**ADDENDUM NO. 01 – PORTAGE PUBLIC SCHOOLS – HAVERHILL ELEMENTARY SCHOOL BP 5:  
FOOTINGS AND FOUNDATIONS**

## ADDENDUM NO. 1 [BP 5]

<b>DATE OF ISSUANCE:</b>	June 15, 2023
<b>PROJECT:</b>	<b>Haverhill Elementary School Bid Package 5: Footings and Foundations</b> 6633 Haverhill Avenue Portage, MI 49024
<b>OWNER:</b>	Portage Public Schools
<b>ARCHITECT'S PROJECT NO.:</b>	21-237.25
<b>ORIGINAL BID ISSUE DATE:</b>	May 25, 2023

SHEET TITLE  
 FIRST FLOOR CMU PLAN  
 SHEET NUMBER  
**S 111**  
 DATE  
 MAY 25, 2023  
 21-237.25

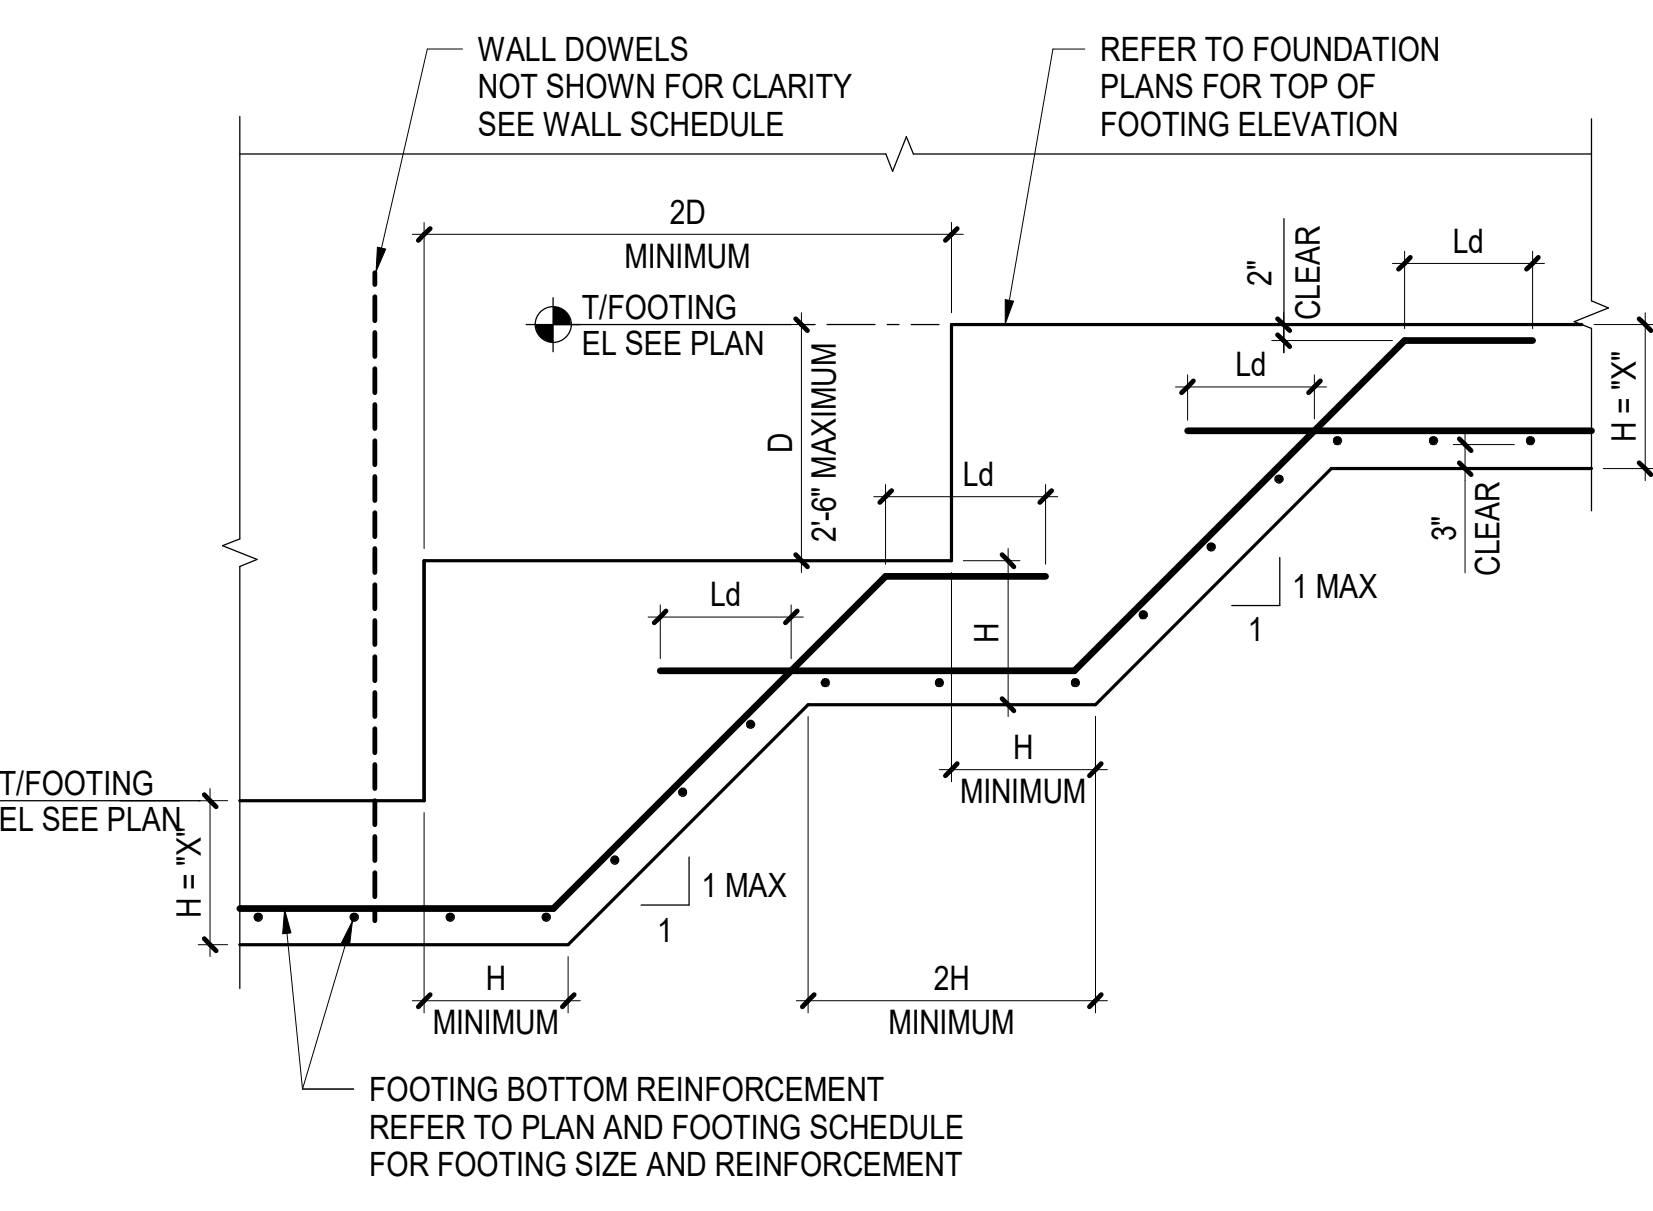
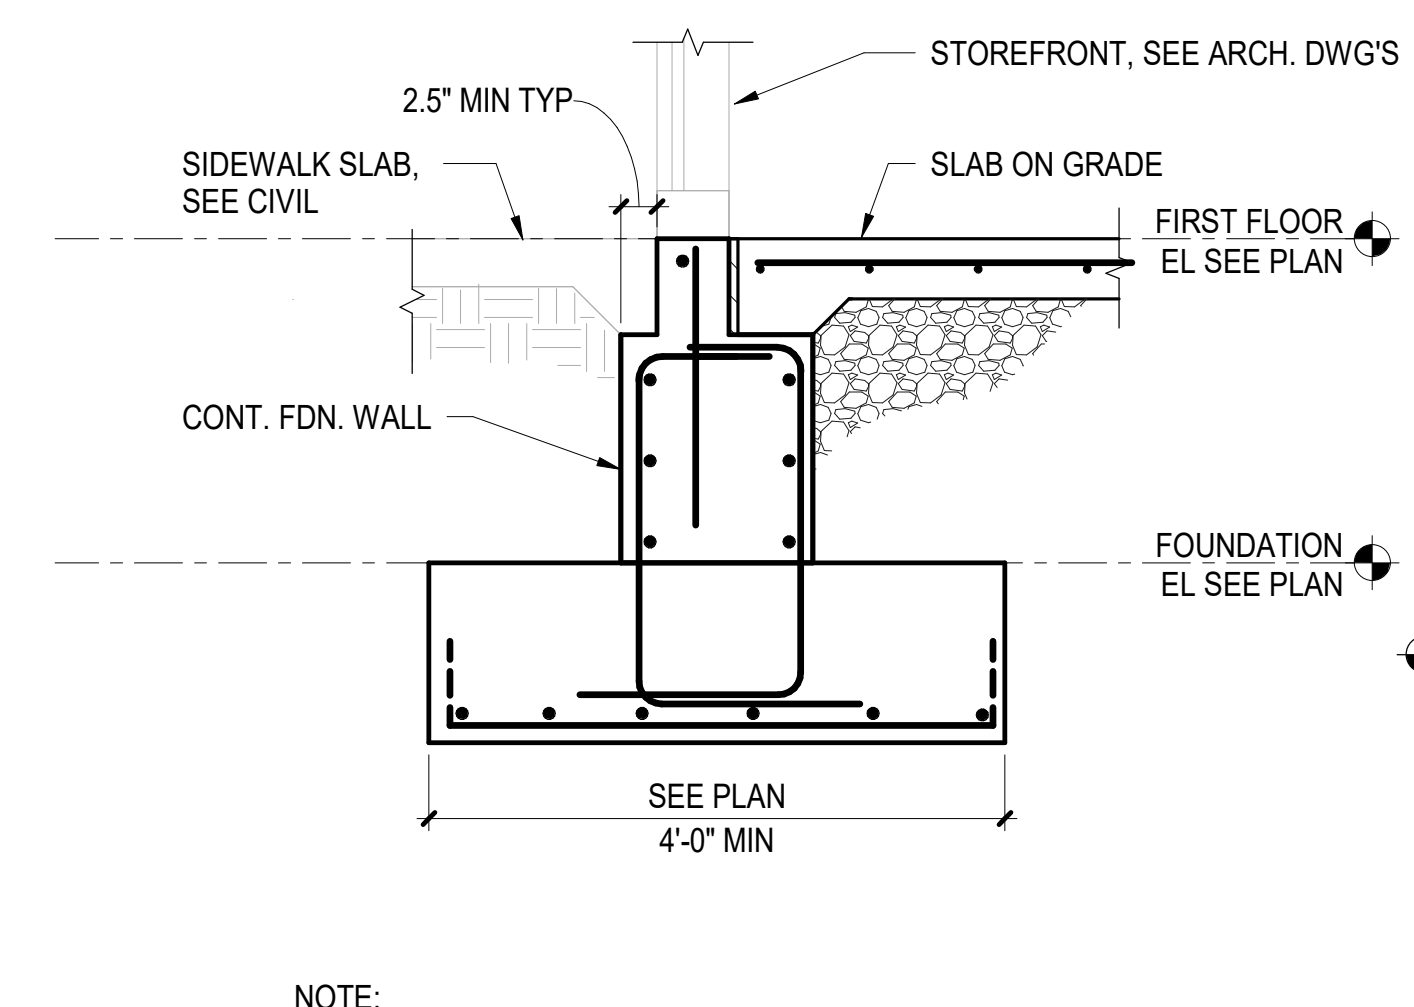
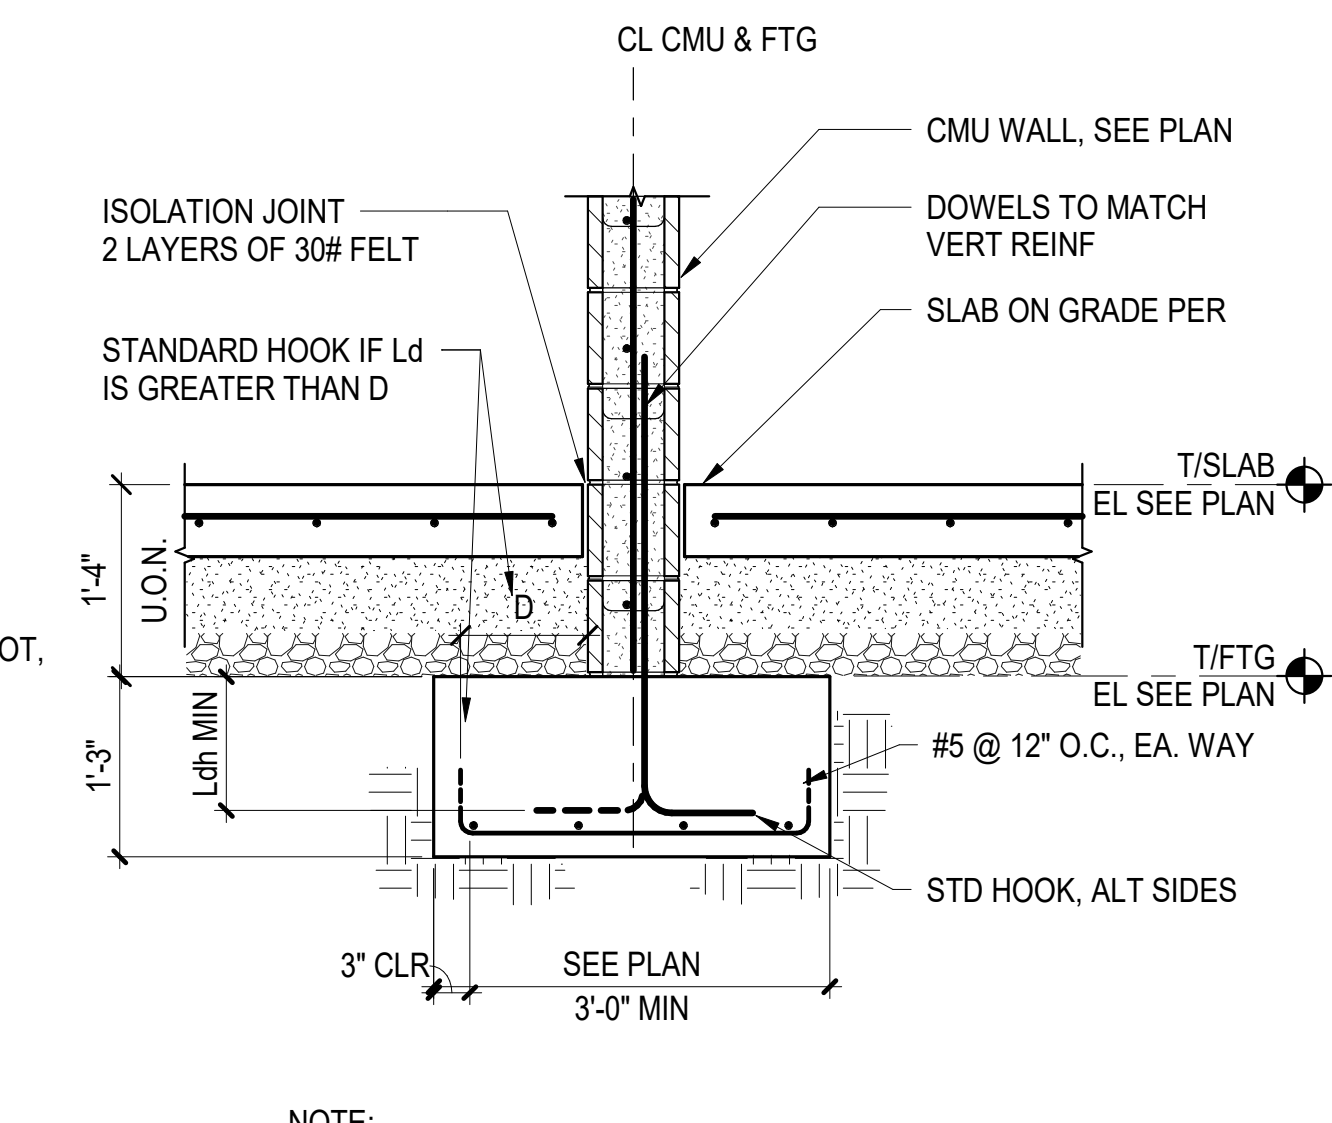
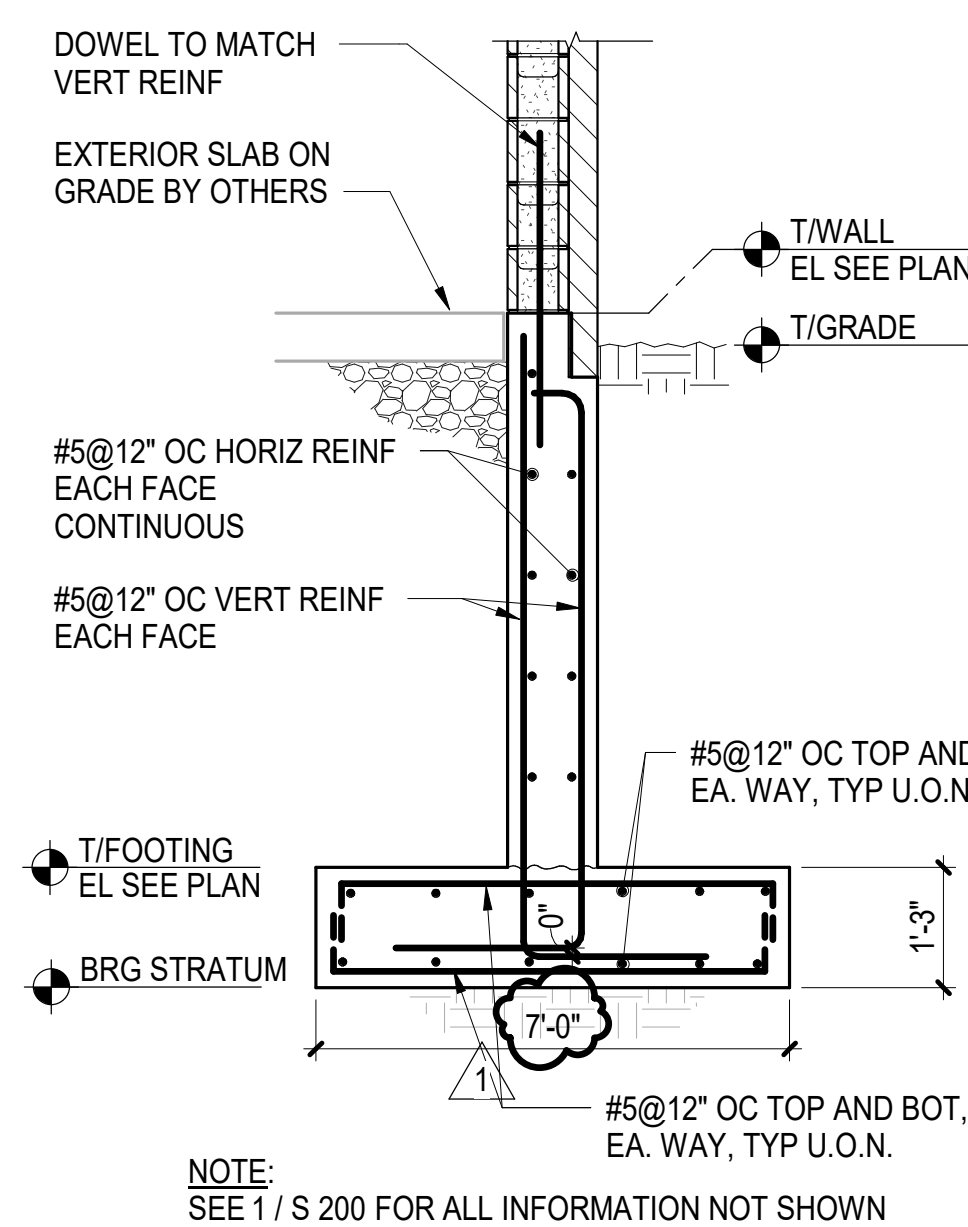
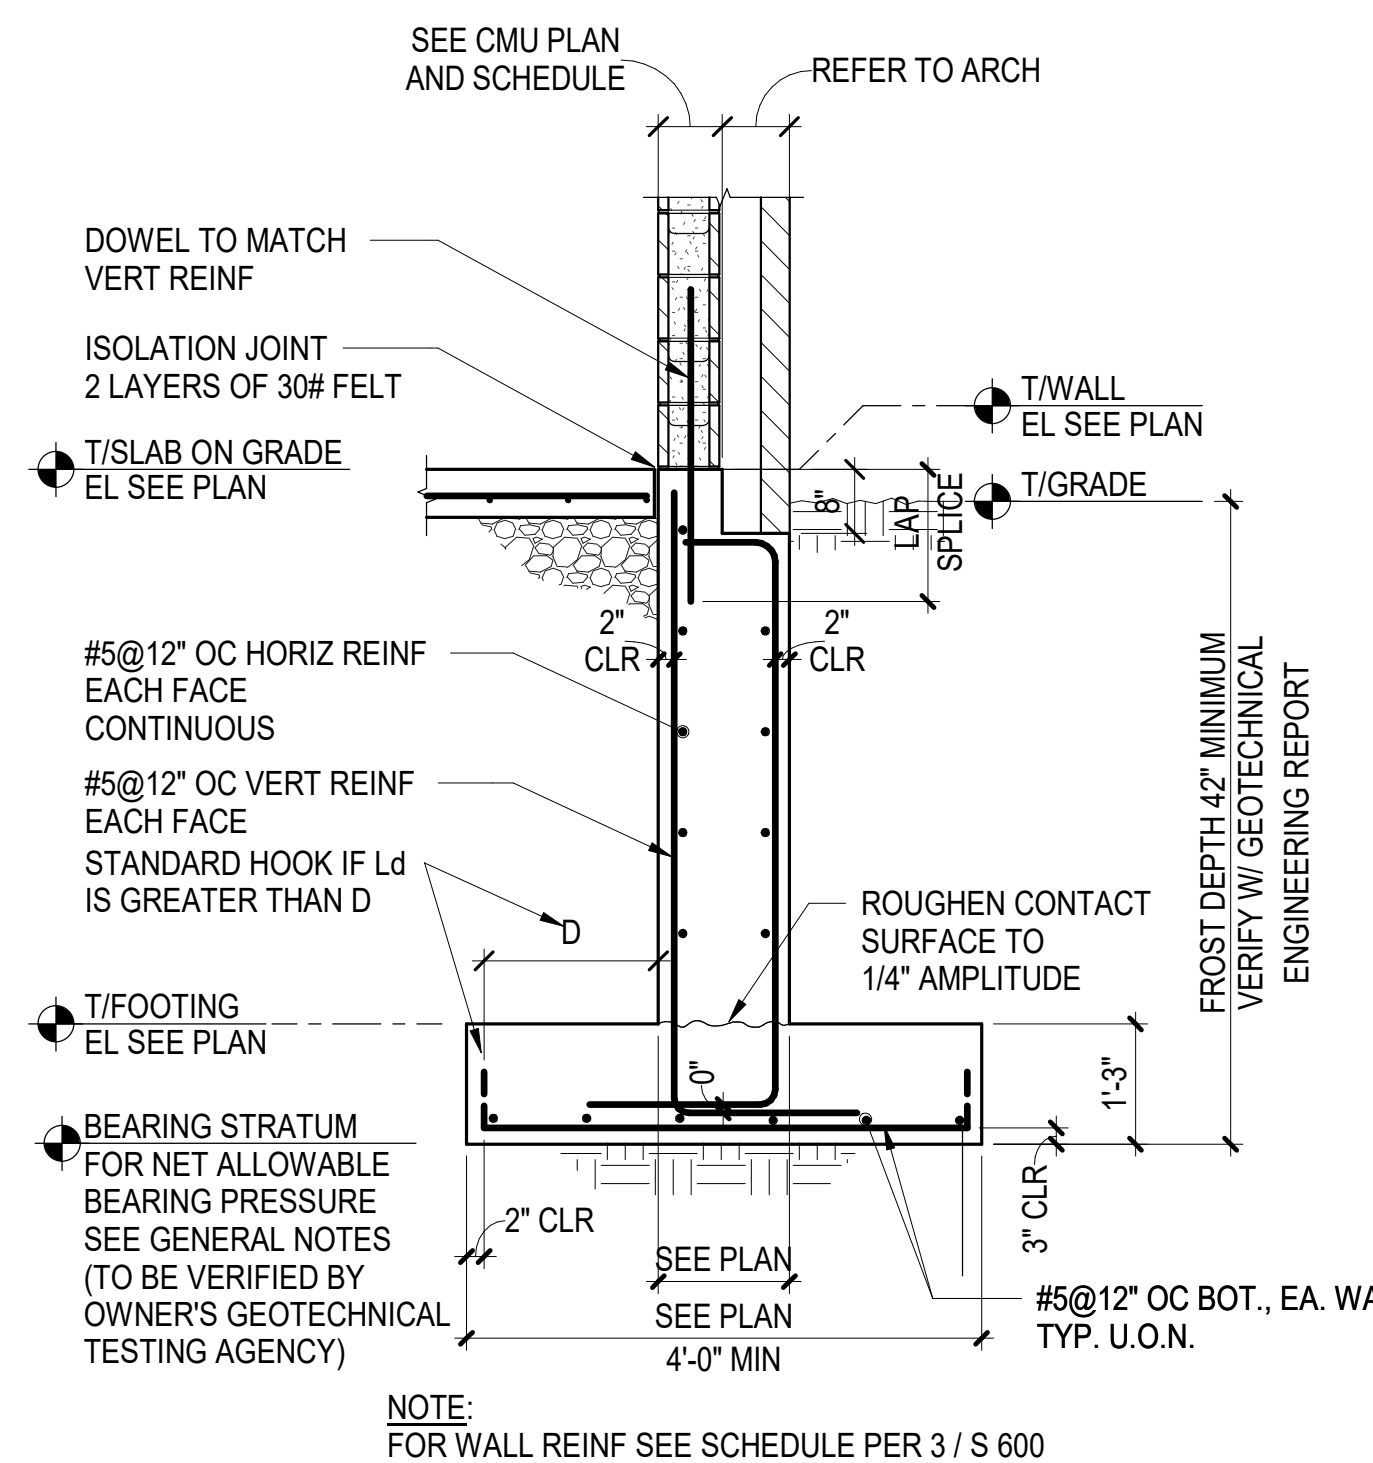
Refer to Sheet(s): S111 [issued for reference only]

- Revised wall type labels per updated CMU schedule on S600

**1A** TYPICAL CONTINUOUS FOOTING AT SCREEN WALL  
 NOT TO SCALE

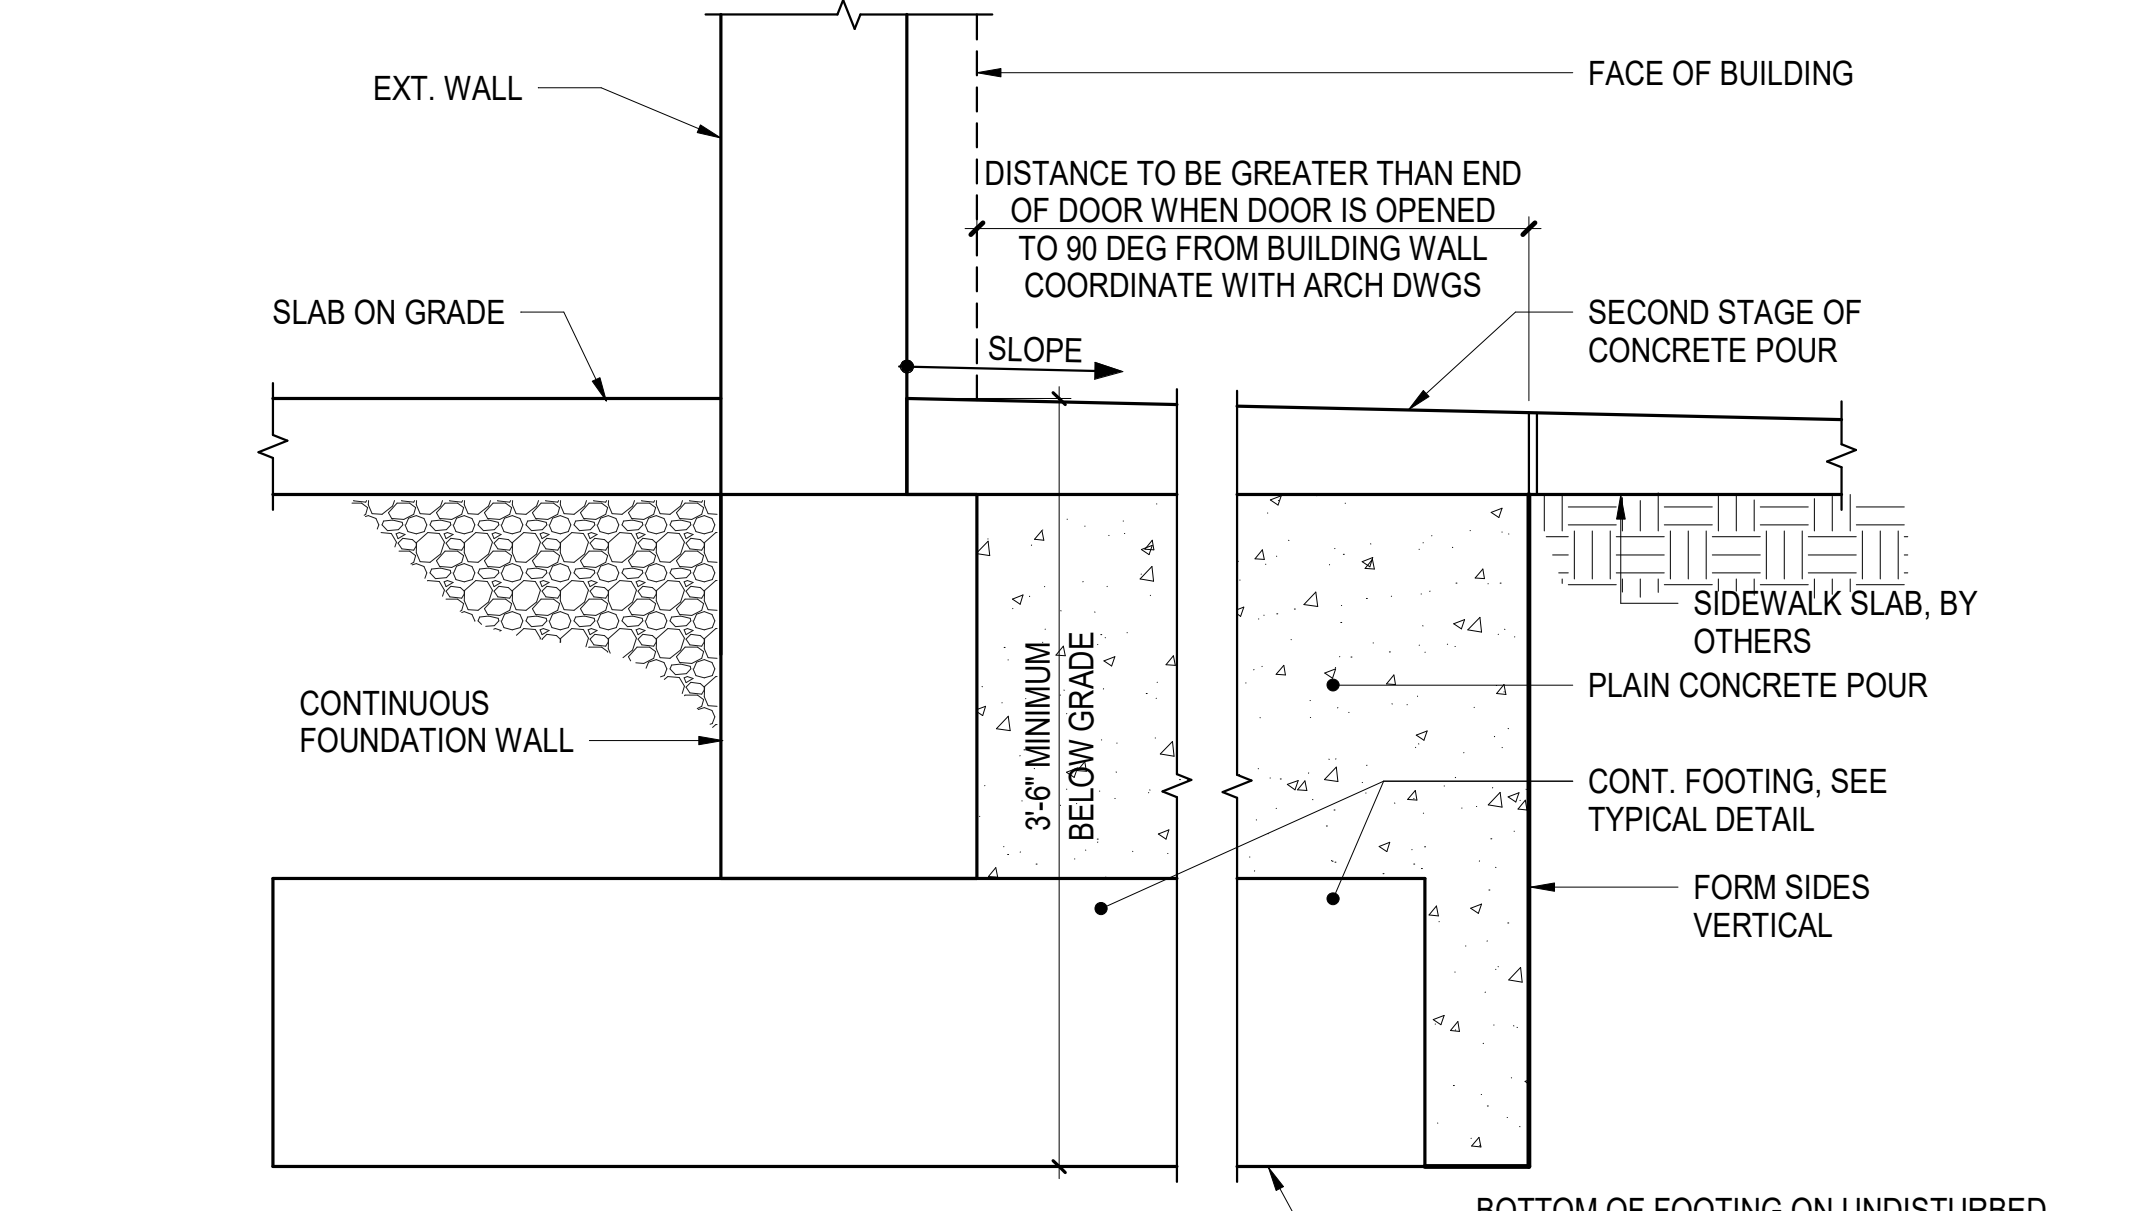
Refer to Sheet(s): S200

- Clarified screen wall footing dimension
